CITY OF ALBUQUERQUE

**RE: 8500 Glendale Ave NE
Reclamation Plan
Engineer's Stamp Date: 01/22/19
Engineer's Certification Date: 02/08/19
Hydrology File: B20D067**

DRAINAGE AND TRANSPORTATION INFORMATION SHEET (REV 6/2018)

DAVID SOULE P.E. #14522	8500 GLENDALE AVE. RECLAMATION PLAN	DRAWN BY DEM DATE 1-19-19 LOT 5, BLOCK 17 ON 3 BLK 17
	 Rio Grande Engineering 1808 CENTRAL AVENUE SUITE 301 ALBUQUERQUE, NM 87108 (505) 872-0888	SHEET # 1 OF 1 JOB # XXXXX

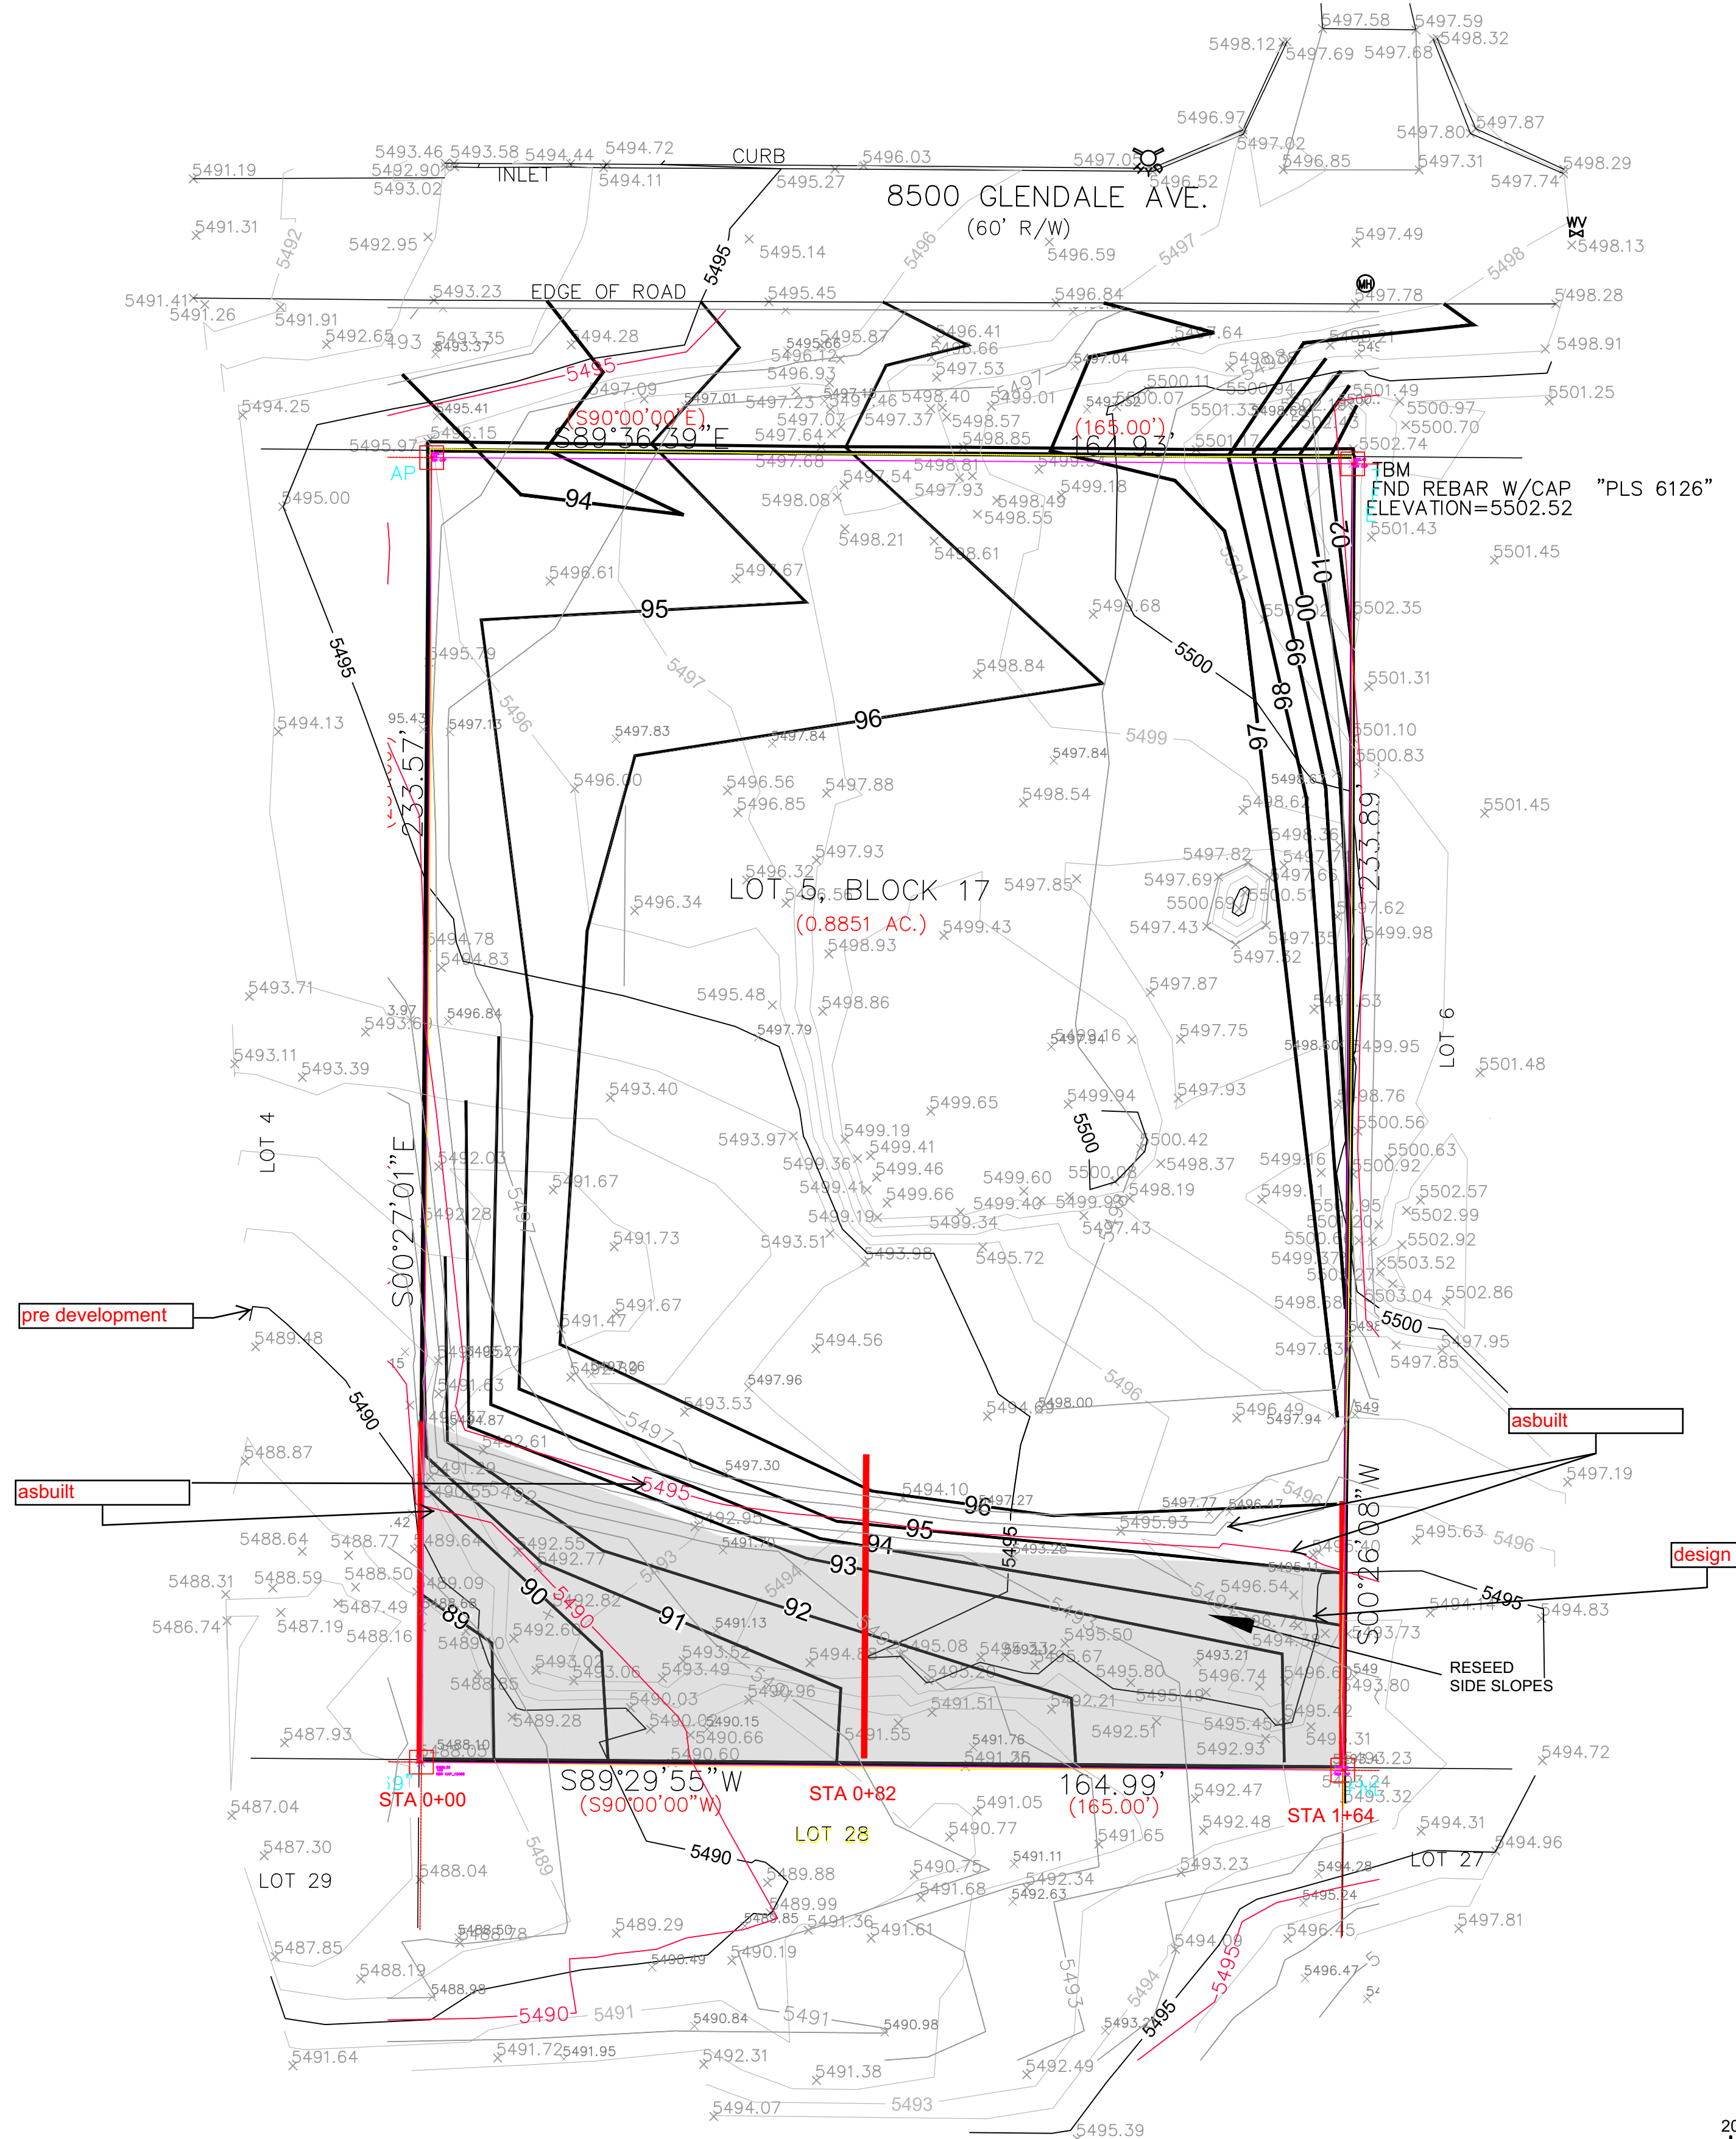
3. Please clarify the finished floor elevation and finished pad elevation. They are currently over the existing grade text and it is difficult to read.

4. Please provide the sections and structural calculations of the scour walls.
5. Please clarify the placement of the leader for the turn 4 blocks @ 5493.00 near the southwest corner of the property. It is currently pointing in the arroyo and not the scour wall.

6. Please provide an additional scour depth equation (3.90 in the Sediment and Erosion Design Guide) for flows at a 90° to the scour wall. The current scour depth equation is only good for flows parallel to the scour wall. This will increase the scour wall depth in the areas where flows are at 90° to it.
